Cloud-Aerosol LIDAR and Infrared Pathfinder Satellite Observation (CALIPSO) Spacecraft

Independent Technical Assessment

NASA Engineering and Safety Center Report	Document #: RP-04-01/ 03-001-E	Version: 0.01
Title:			Page #: 1 of 29
CALIPSO Independent Technical Assessment/Inspection (ITA/I) Report

Report of the ITA Findings to the NESC

Figure 1. Schematic of CALIPSO Propulsion System

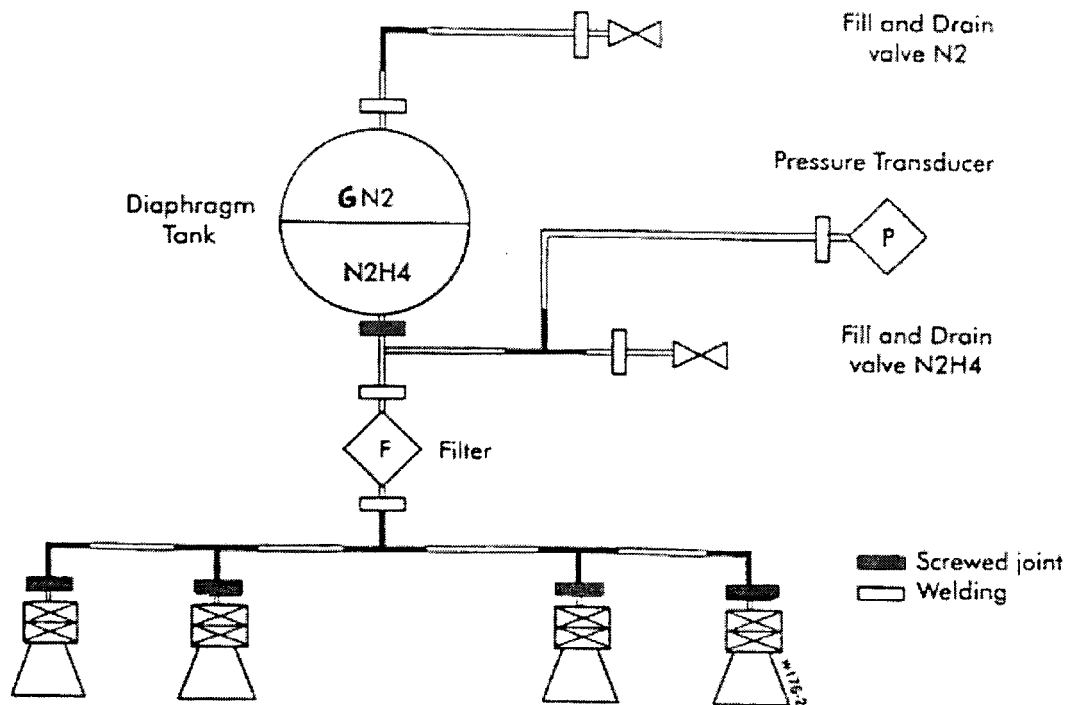
The assessment team observed that there is no isolation valve downstream of the CALIPSO propellant tank. The GRC members were of the opinion that the program needed to address this issue in response to a specific NESC recommendation and offered the following:

“The lack of an isolation valve in the Proteus bus design maximizes the potential for loss if any one of the three hazardous events were to occur, since there would then be no expedient means to stop the flow of hydrazine from the propellant tank. As a result, the worst-case failure effect is that most of the hydrazine in the propulsion system would be released, possibly causing a catastrophic event (personnel injury or fire). There is no evidence that a formal risk assessment was performed to address these three hazardous events related to the design decision to omit an isolation valve.”

Figure 2. MS 33656 A/N fitting installation detail

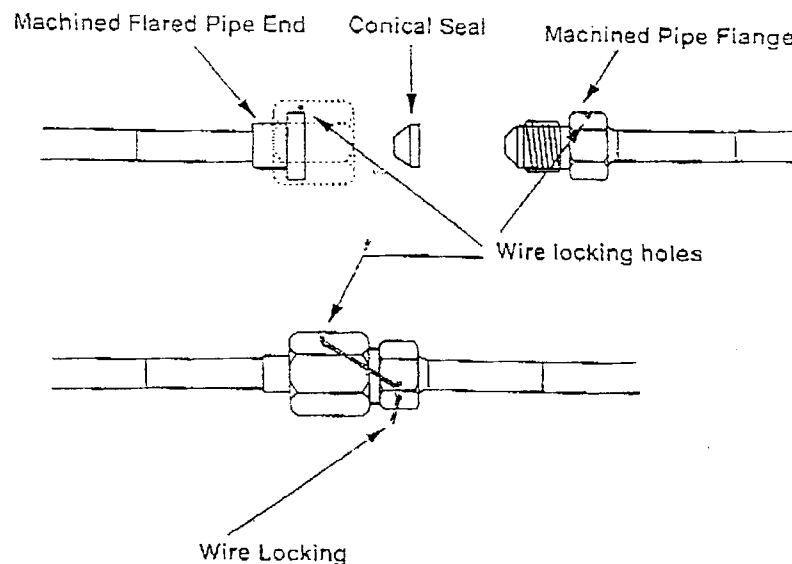
Properly welded fluid connections are inherently more reliable than mechanical fittings and should be incorporated in fluid propulsion system designs when possible. There are some circumstances, however, under which mechanical fittings offer an appropriate design solution. Ready interface to off-the-shelf parts, ease of maintenance, or potential for damage to soft goods during welding all may dictate use of threaded joints. MS-33656 type 37° A/N-fittings have been employed successfully in aerospace applications for many years and are acceptable for limited use providing they are (1) properly assembled, (2) validated by leak check as an assembly before use, (3) exposed only to temperature, pressure, vibration and shock environments for which they are certified, and (4) incorporate a secondary locking feature. The Proteus bus uses five such fittings; one at the hydrazine tank outlet and one at each of the thruster inlets (see Figures 2 and 3 for details). While lock-wire is used as a secondary locking feature, it is suitable only for preventing significant rotation of the B-nut and full disengagement of the fitting. Lock-wire alone will not prevent loss of joint preload⁸ with subsequent reduction of clamping force at the sealing surfaces, and thus cannot be counted upon to prevent a fitting from leaking.

NESC-R-001 - Program shall demonstrate that Alcatel training and/or assembly documentation provided for proper lubrication of fluid fittings during assembly. Assembly procedures shall clearly delineate the type, quantity and location where lubricant was applied and ensure sealing surfaces were kept dry and free of any contaminant.

Figure 4. Moog Dual Seat Dual Servo Thruster Valve

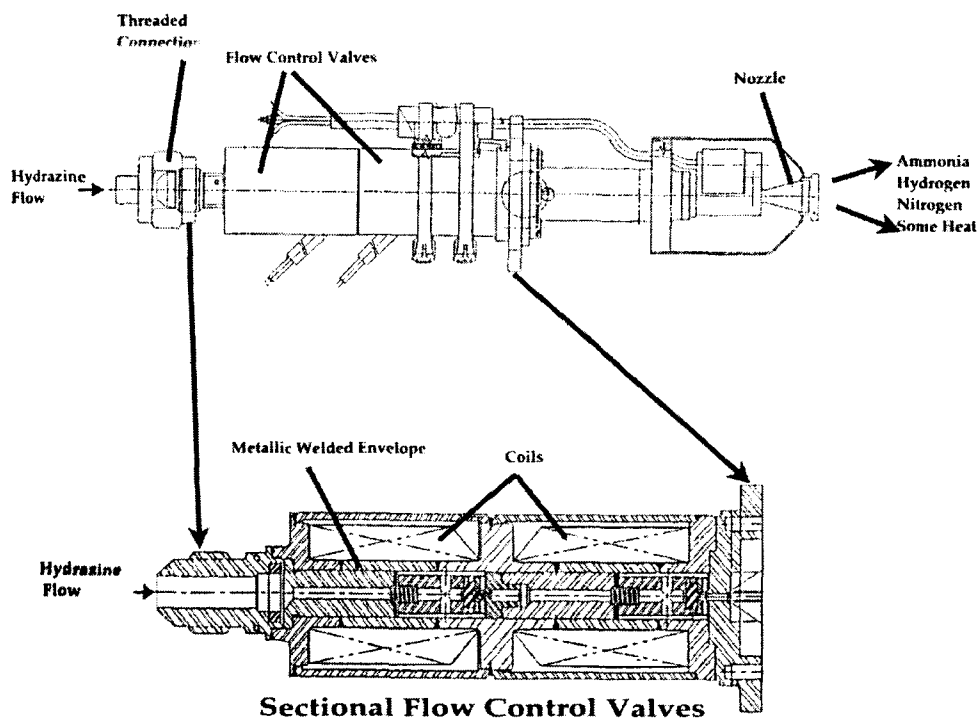
NESC concludes the potential for external leakage from the thrusters either internally (across the control valves) or externally (thruster casing or seal) poses acceptable risk to personnel providing the program conducts an adequate pre-servicing leak check of each valve. While the program did indicate such testing was planned, NESC was not provided a specific description of the test or its pass/fail criteria.

During a site visit to Aerojet Space Propulsion, an issue with Moog thruster valves similar or identical to the Proteus valves came to light. A manufacturing process change by Moog resulted in a recall investigation on suspect serial number valves²¹. The program was notified of this and was working to clear the CALIPSO Proteus bus valve set.

NESC-R-007 – Program shall demonstrate that pre-servicing thruster leak checks will be adequate to validate system integrity. Leak check procedures shall test each valve independently and shall specify test method, equipment to be used, media, test pressure and allowable leak rate.

NESC-R-008 Program shall verify that the Proteus Moog valves on CALIPSO do not have defective plunger assemblies.

**Figure 5. Thruster Circuit Schematic with New Test/Arm Plugs
(PM refers to spacecraft processor module)**

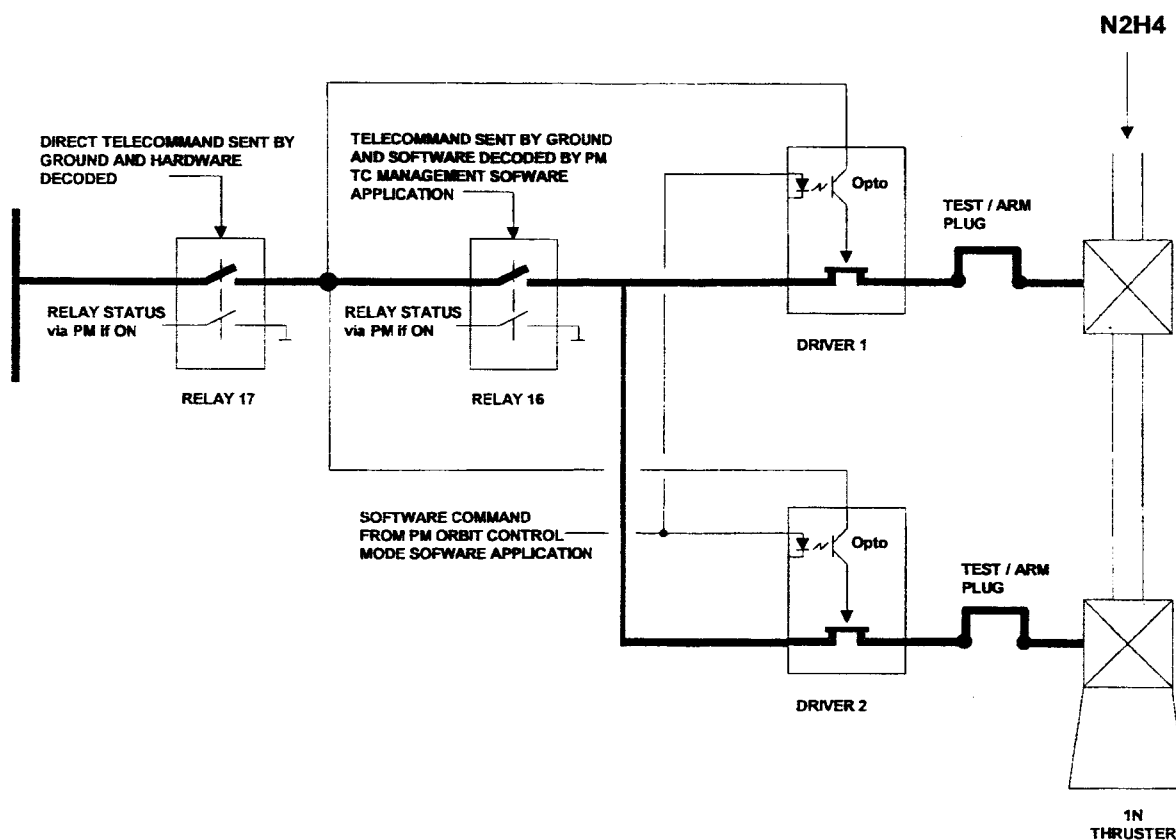
The Proteus thruster firing circuit incorporates a number of controls to ensure valves are not inadvertently opened causing a thruster to fire. NESC concurs the controls are adequate, but recommends further steps be taken to positively preclude the possibility of an inadvertent command during periods of dynamic testing, especially power-up. A schematic of the thruster wiring circuit is shown in Figure 5. It is worth noting that the Astrium specification sheet for the thruster lists nominal flow rate at 0.44 grams per second. Even with all four (4) thrusters firing at nominal flow rate, it would take 4.7 hours to drain the 30 kilograms of hydrazine in the propellant tank.

NESC-R-009 – Program shall demonstrate that test procedures verify relays 16 and 17 are open before power is applied to the spacecraft. Since the design incorporates latching relays, verification of the last stable state by data retrieval or written record is acceptable.

NESC-R-010 – Steps for inserting and removing test/arm plugs shall be explicitly called out in the ground processing timeline. Final installation for flight shall occur as late as possible; until that time, plugs shall only be installed as required for thruster valve testing.

NESC-R-011 – Program shall verify that all thruster firing circuit inhibits function as designed.
